Marine Mk IV liferafts — Canopy : *Inspect the canopy doorway zip sliders*

1. Introduction

This service bulletin tells service personnel to inspect each canopy doorway metal zip slider for corrosion and if necessary replace with resin zip sliders.

FIGURE 1
Metal and resin zip slider

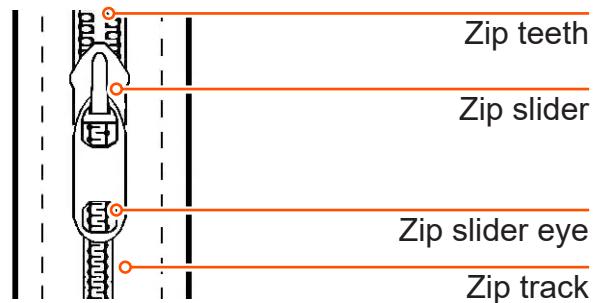
Each Mk IV liferaft has a canopy. The doorways on the canopy have two zips with metal zip sliders. Survitec has found that these metal zip sliders might experience corrosion. If you find corrosion on a metal zip slider then you must replace all metal zip sliders with a resin zip slider.

Part number	Description	Quantity
02426001	4 kgf thread	AR
08110009	525 lbf cord (500 mm long)	8
12750009	Resin zip slider (refer to Figure 1)	AR

FIGURE 2
Remove the metal zip slider cord loops

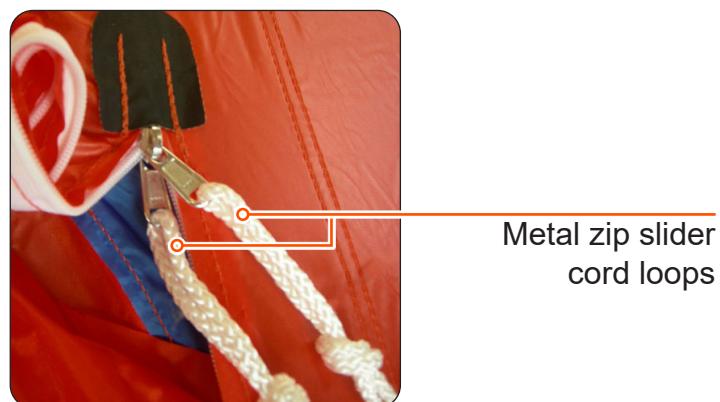
- (c) Go to the outer metal zip slider.
 - (d) Use fresh water and/or vinegar to remove all corrosion from the metal zip slider.
 - (e) Remove the metal zip slider cord loops. Refer to **Figure 2**.

FIGURE 3
Remove the zip securing stitches

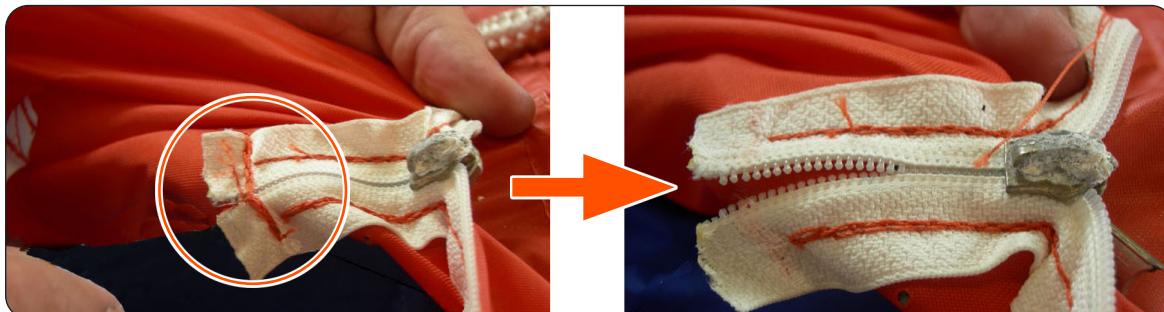
- (f) Use a stitch picker to carefully remove the zip securing stitches from the back of the zips. Refer to **Figure 3**.

FIGURE 6
Orientate and align the inner resin zip slider
(metal zip slider shown for illustrative purpose only)

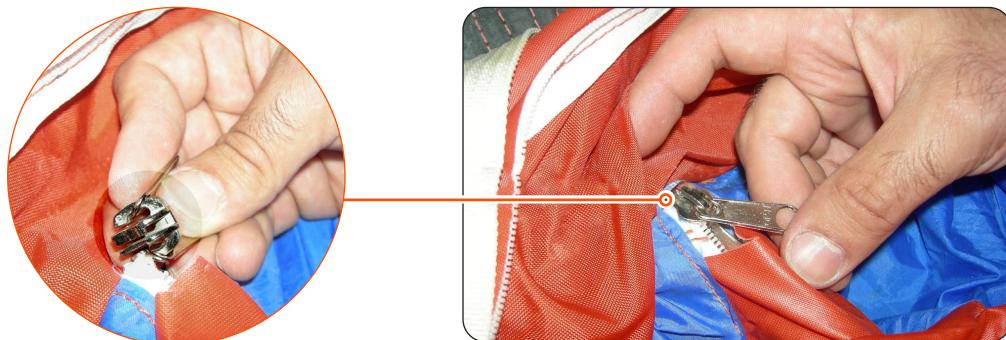
NOTE: Make sure that the flat side of the resin zip slider is to the inside of the liferaft when the zip is closed.
Refer to **Figure 5**.

- (a) Align the inner resin zip slider evenly onto both zips and pull the zip closed. Refer to **Figure 6**.
 - (b) Use 4 kgf thread to stitch the zip ends together.
 - (c) Put the inner resin zip slider into the canopy zip channel and push it fully through.
 - (d) Get two 500 mm lengths of 525 lb cord.
 - (e) Make a cord loop for the resin zip slider:
 - 1 Put one end of one length of 525 lb cord through the resin zip slider eye and pull it through half way.
 - 2 Collect the flying ends of the 525 lb cord and tie them together with an overhand knot.
 - (f) Do step (e) again to attach one more 525 lb cord loop to the eye of one more resin zip slider.
- (6) Do steps (4) and (5) again to remove one more inner metal zip slider and install one more inner resin zip slider.
